**PUBLIC INTEREST REVIEW FOR GROUND WATER APPLICATIONS**

TO: Water Rights Section Date 11/30/2009  
 FROM: Ground Water/Hydrology Section Jen Woody  
Reviewer's Name  
 SUBJECT: Application G- 17287 Supersedes review of n/a  
Date of Review(s)

A. GENERAL INFORMATION: Applicant's Name: Kellogg Kin, Inc. County: Jackson

A1. Applicant(s) seek(s) 0.11 cfs from 1 well(s) in the Middle Rogue River Basin,  
Sardine Creek subbasin Quad Map: Gold Hill

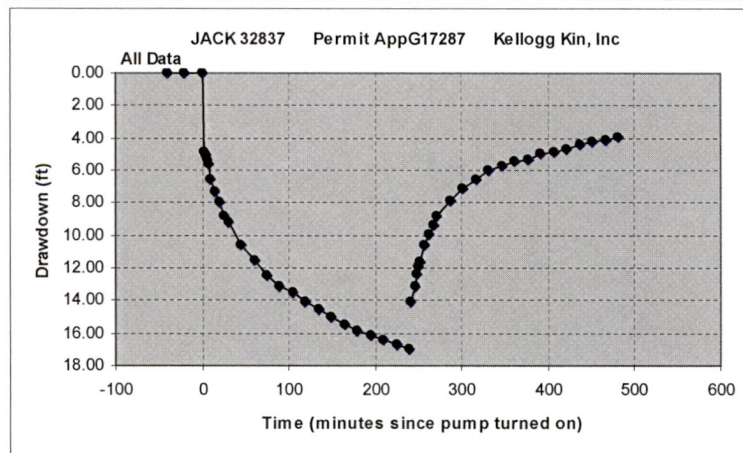
The pump test conducted by Hydro-Flow, Inc. on 11/9/2001 shows continuing decline throughout 4 hours of pumping at 50 gpm and incomplete recovery in the well after 4 hours (see graph below). This suggests the well may not yield 50 gpm in the long term.
